**PLANNING DEPARTMENT
CURRENT PLANNING STAFF ANALYSIS
SITE PLAN REVIEW**

CASE NO.: 2017-0017

Ship Creek Development, LLC is seeking final site plan approval of their condominium project, *Downtown Edge at the Rail*, which is located at the northwest corner of 2nd Avenue and Christensen Drive.

Subject: Case 2017-0017; Major Site Plan Review per AMC 21.15.030 (Old Code) for a Condominium Development (“Downtown Edge at the Rail”) in the Planned Community (PC) District.
(X-Ref: S12330)

FIGURE TITLE: A-A' SLOPE CROSS SECTION PROFILE	
PROJECT NAME: SHIP CREEK DEVELOPMENT	
PROJECT ID: 4385-16	FIGURE NUMBER: 5
PROJECT LOCATION: ANCHORAGE, AK

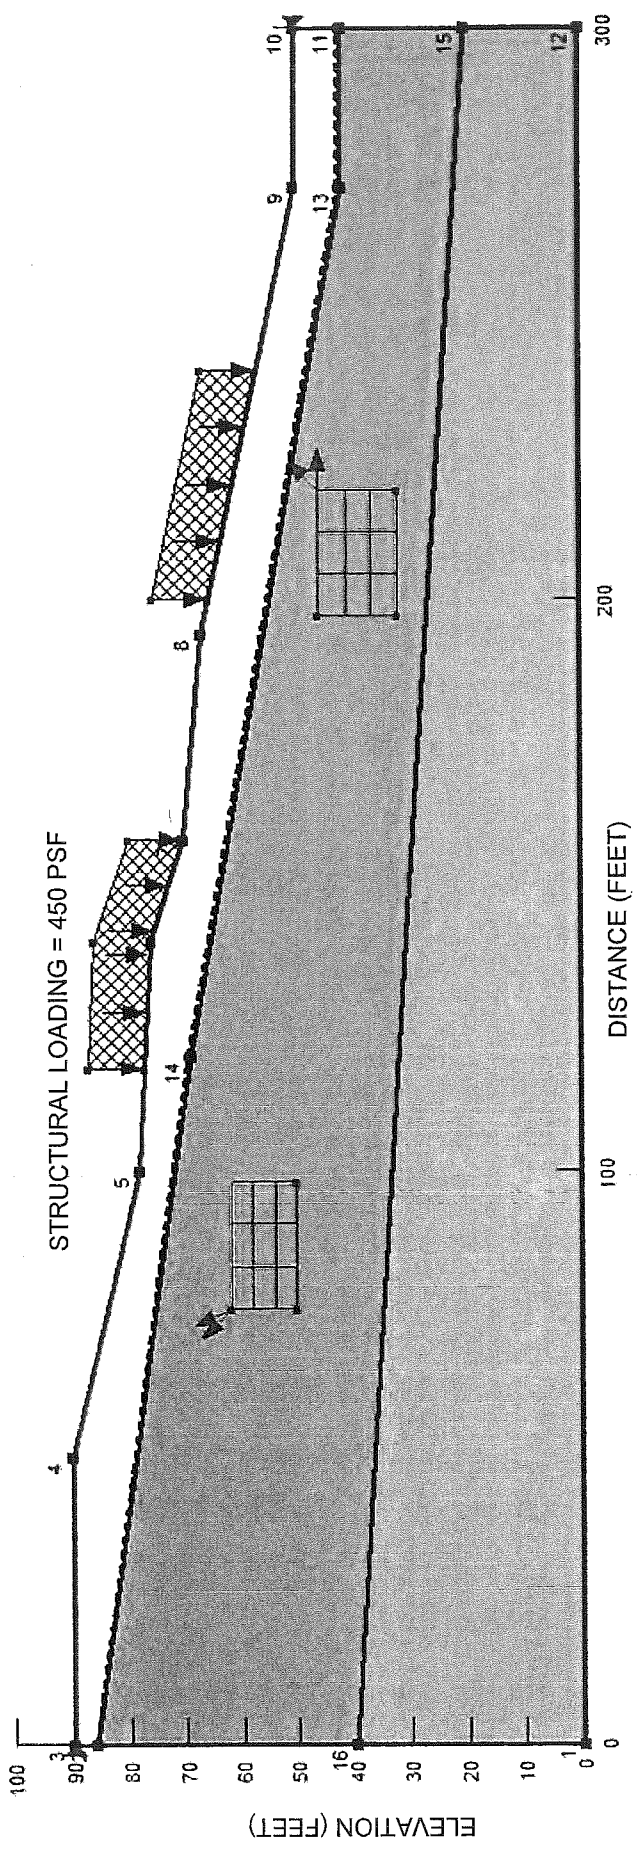
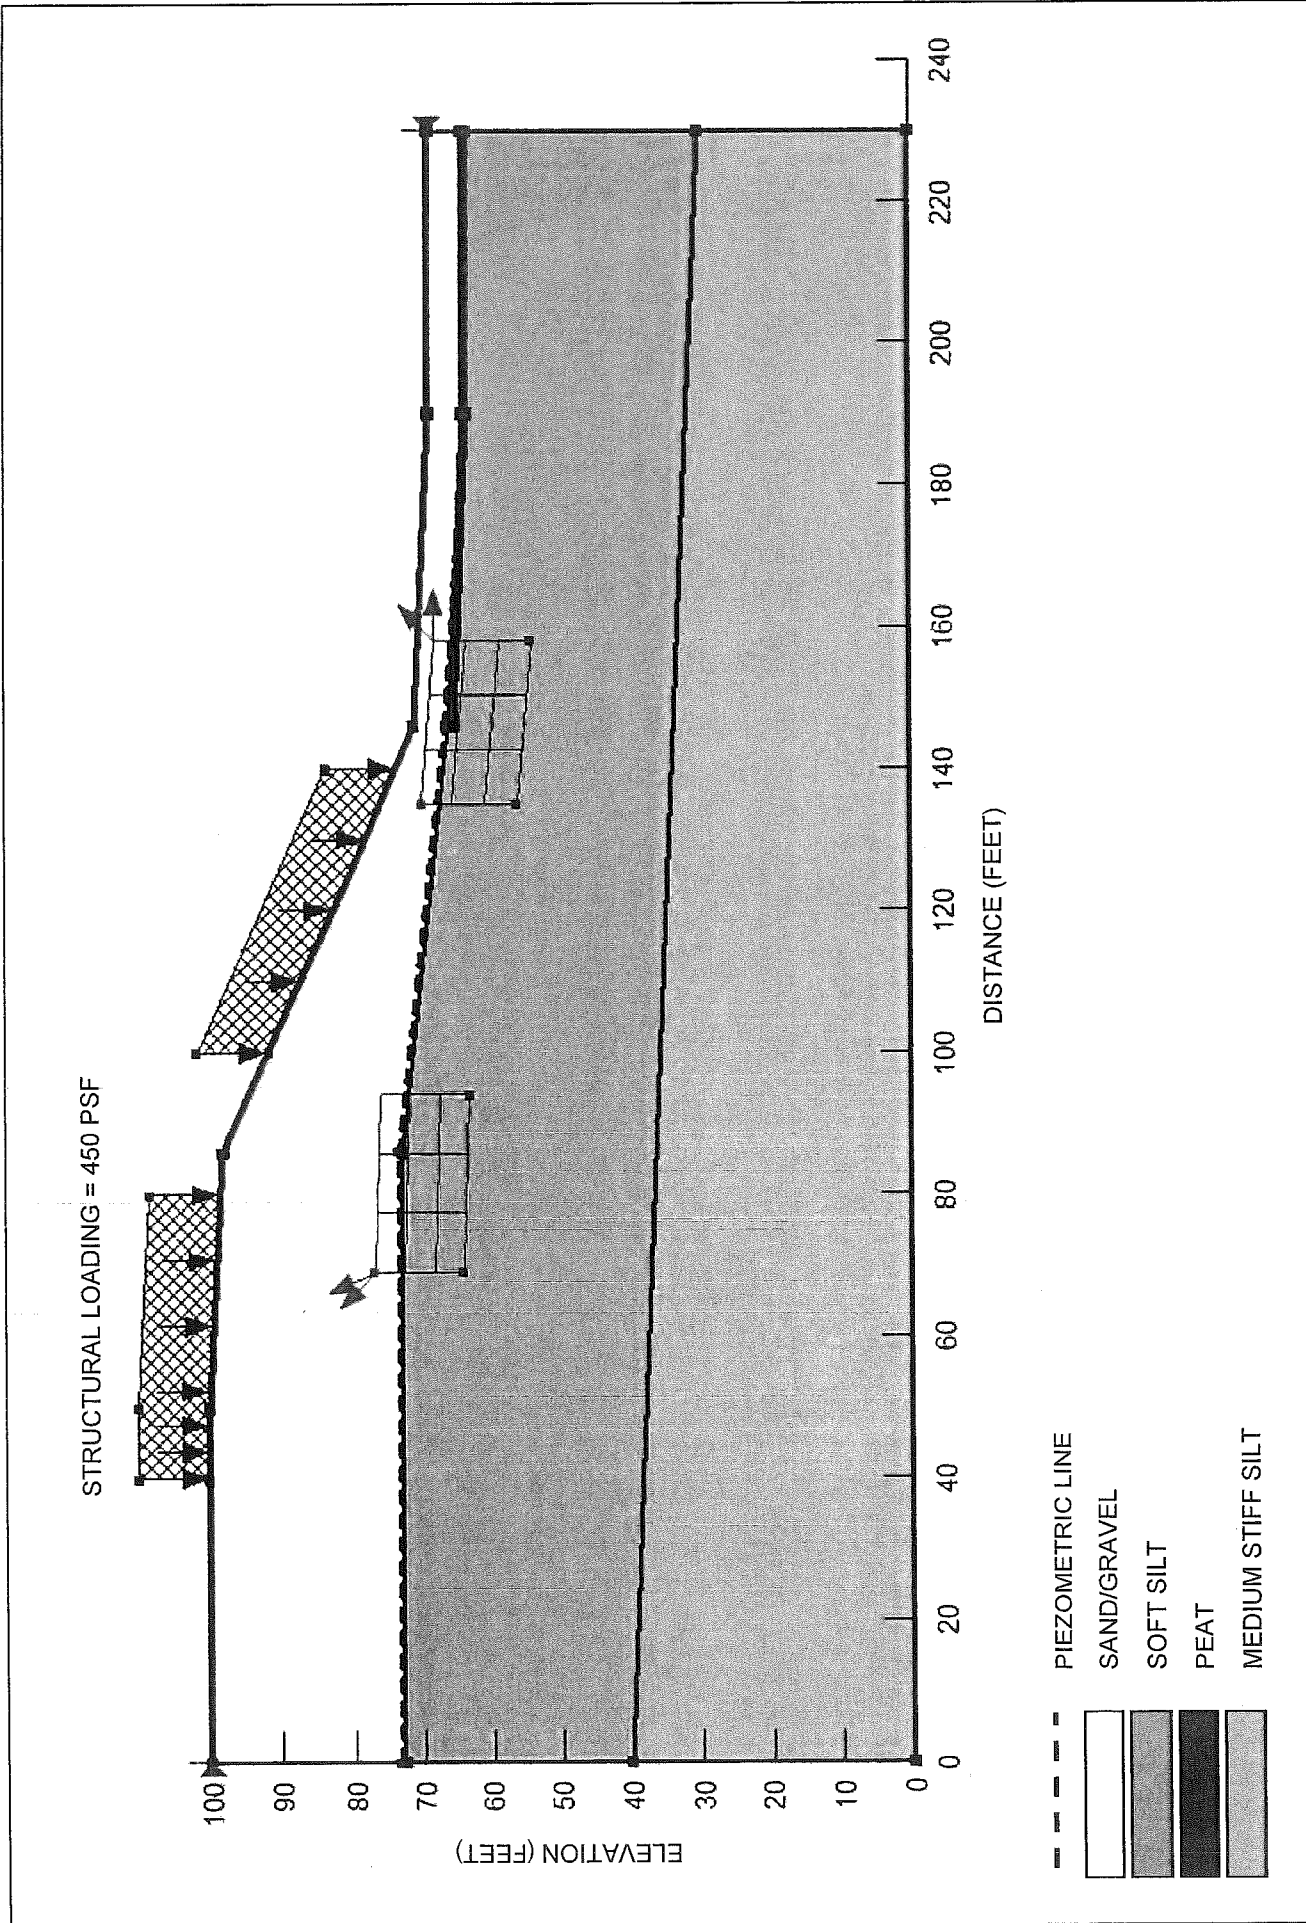
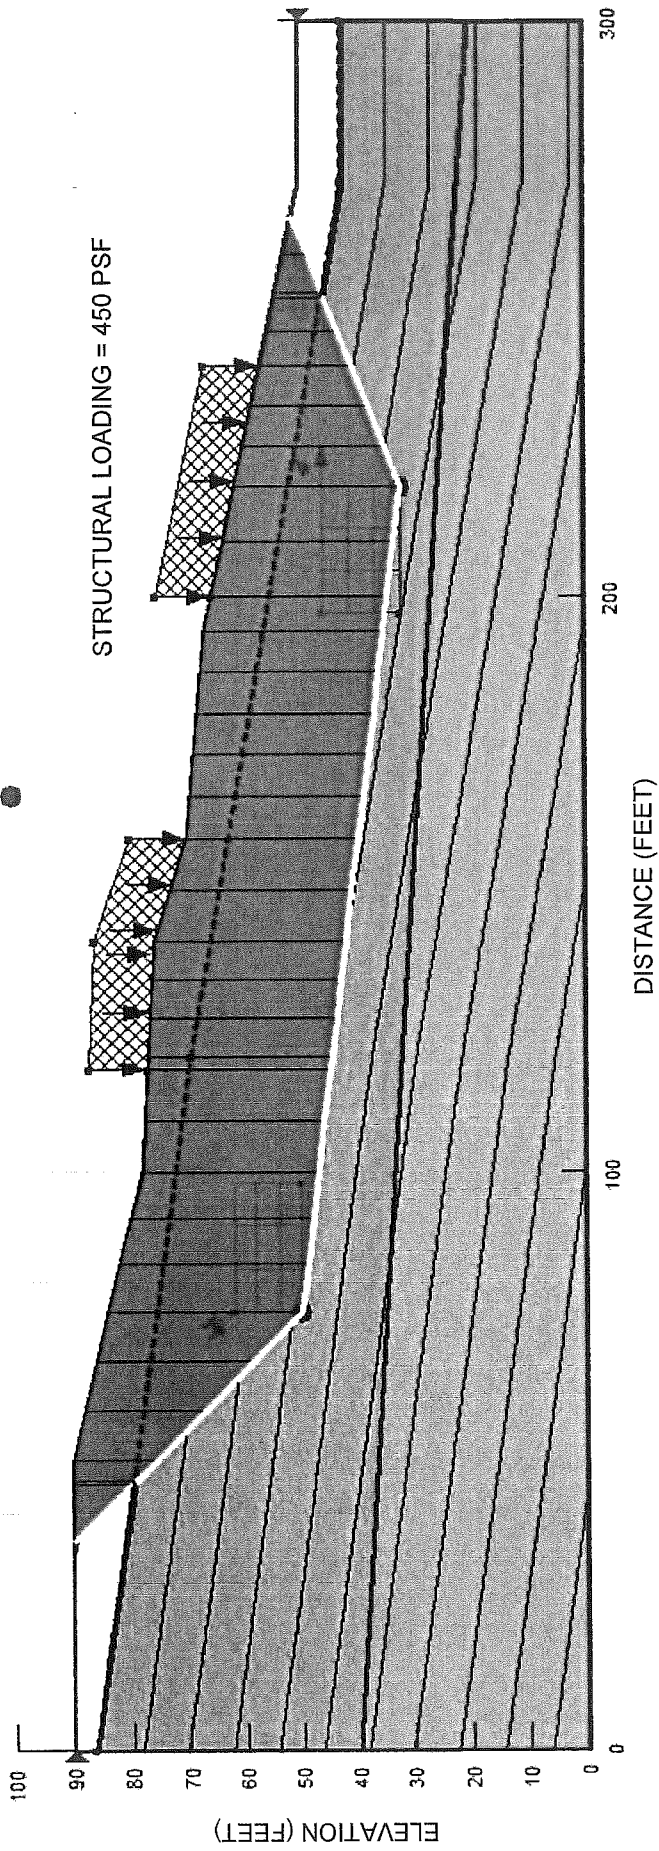
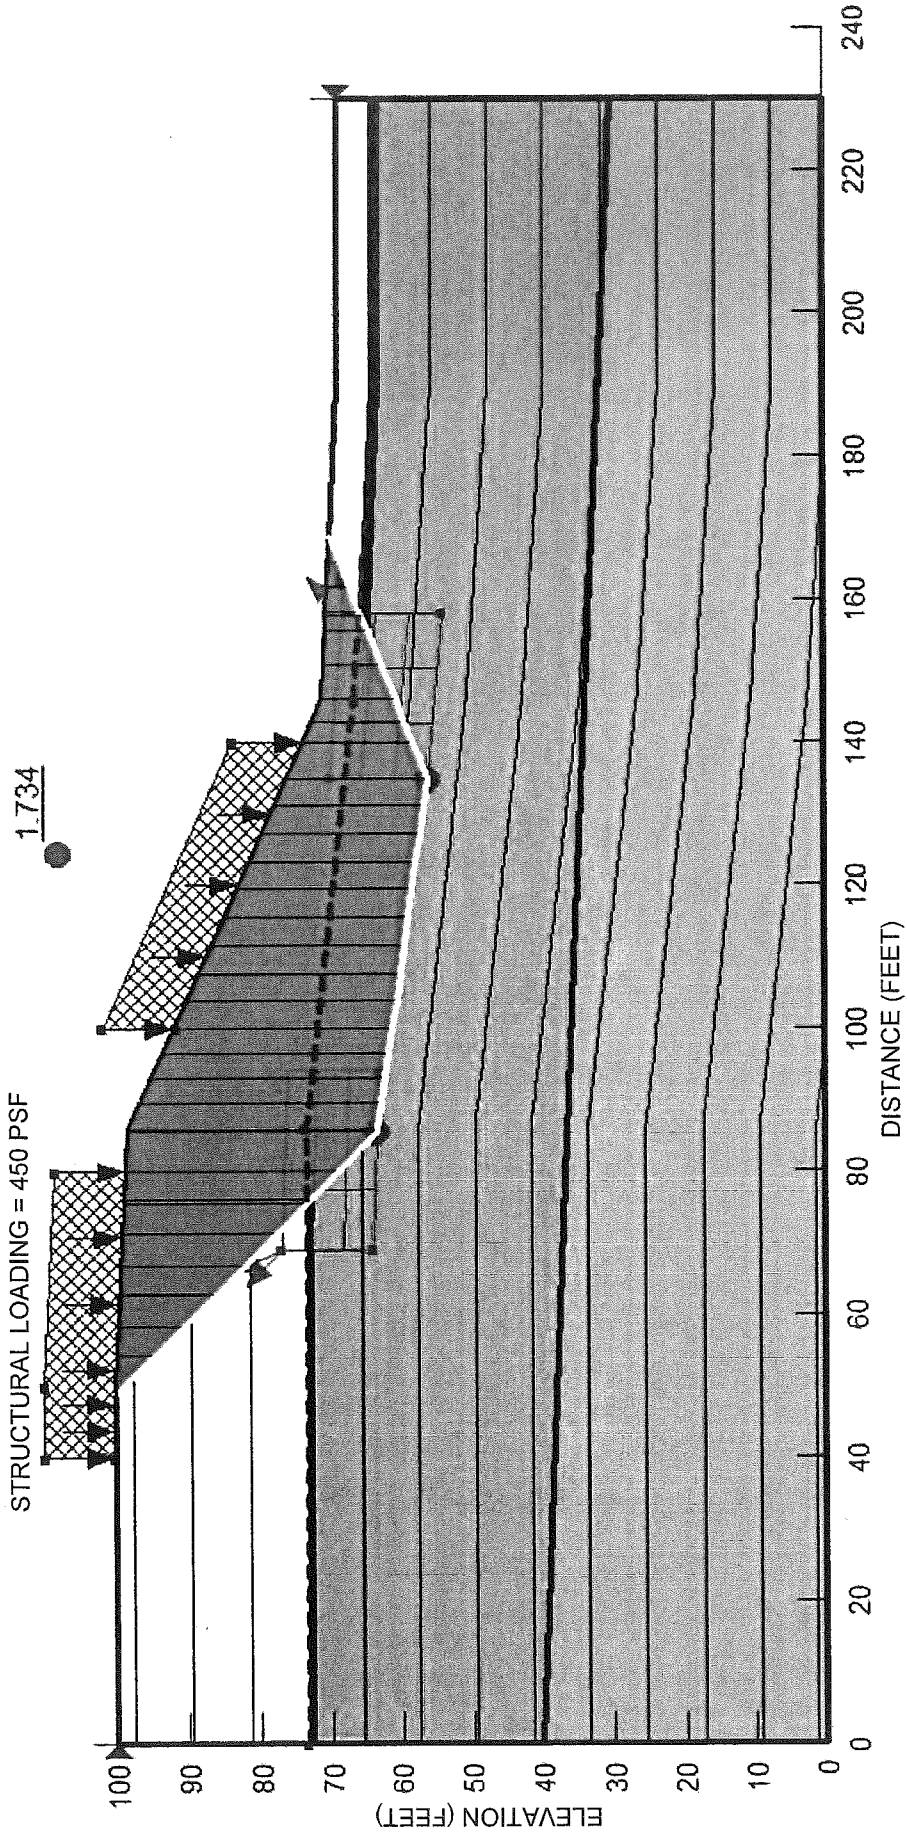
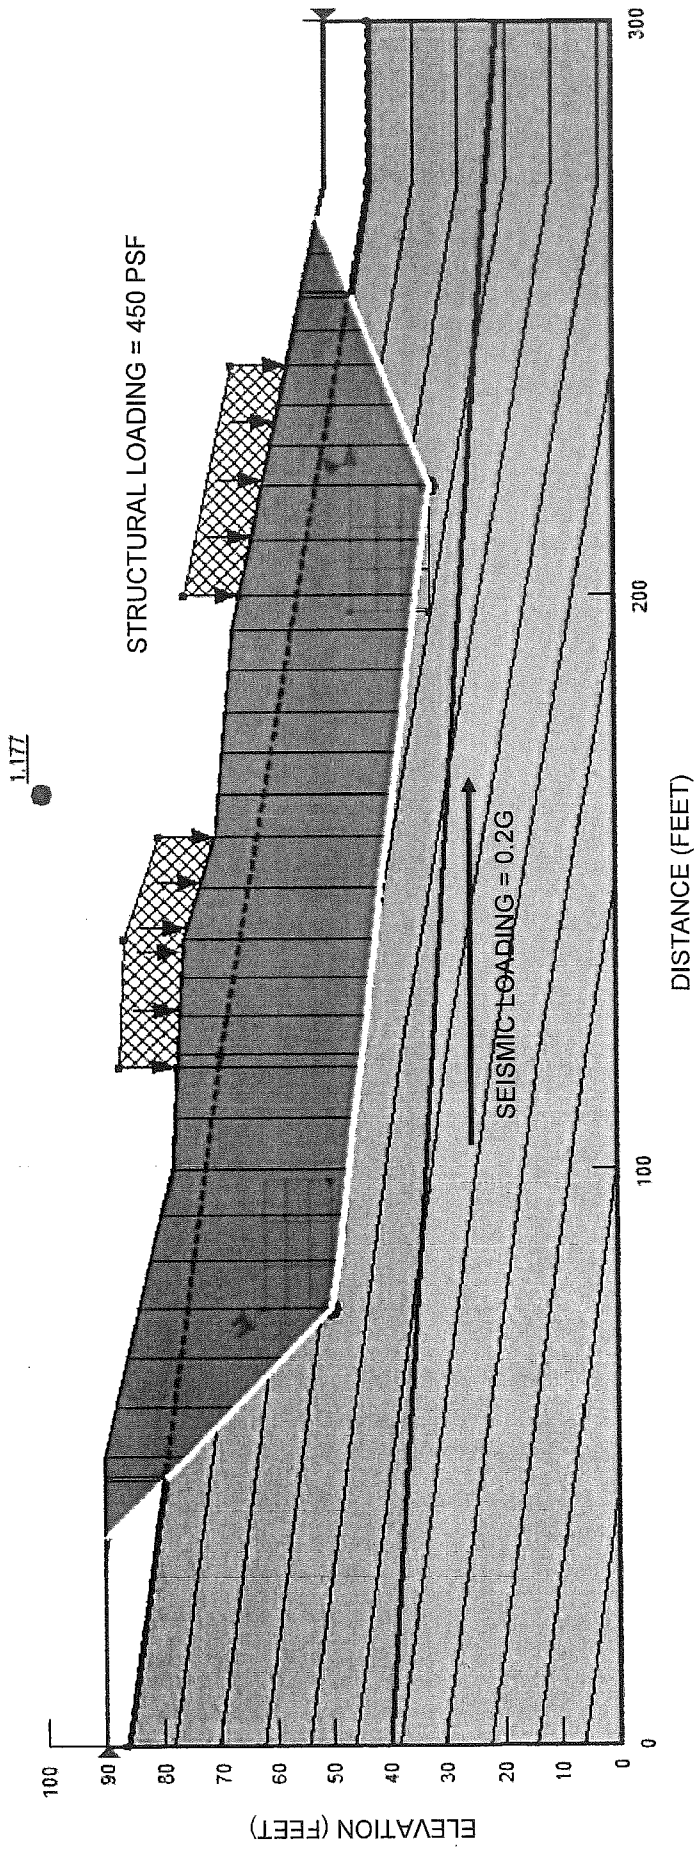
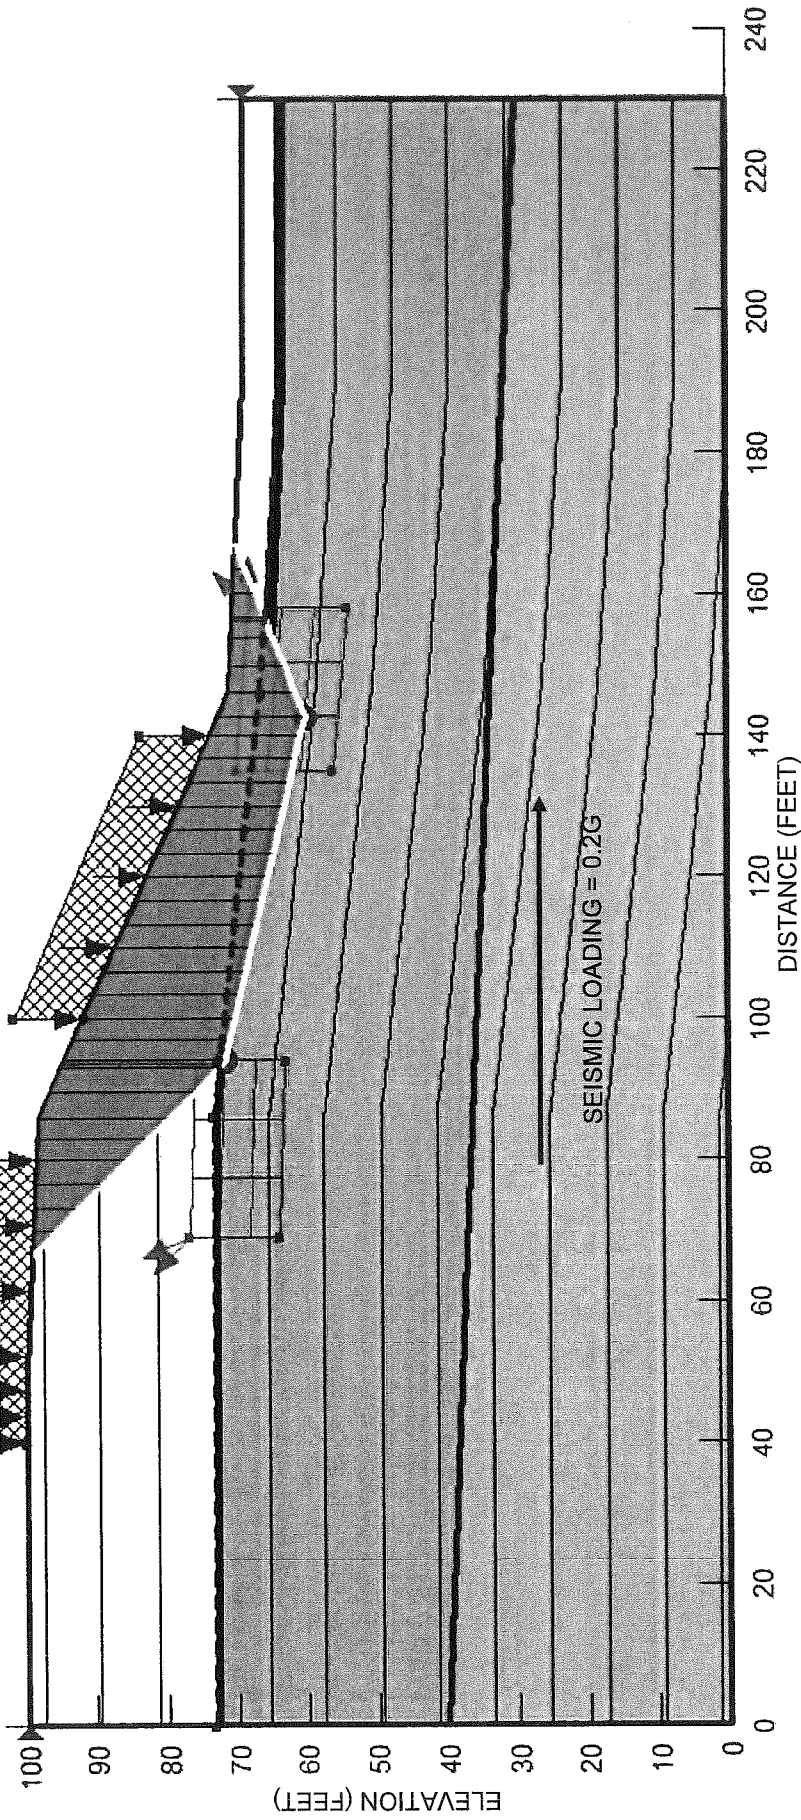
1. The general soil cross sections in Figure 3 and Figures 7 through 13 are not supported by the logs for NGE explorations at the site. Please address or correct the apparent discrepancies listed below:

- a. Figures 3, 7 through 9, 11 and 13 show four or more distinct general soil strata within the depths drilled in Borings B-1 and B-5; while the logs for those two borings only illustrate two general soil units.

- c. Please perform a sensitivity analysis on the various soil strengths assumed in the model.
3. Please revisit the model and ensure that a large enough extent is evaluated. One of the models (Figure 12) shows a failure plane beginning at the edge of the model. This is not good modeling practice, and the modeler needs to consider the program’s search algorithm and verify the appropriateness of the model extents.
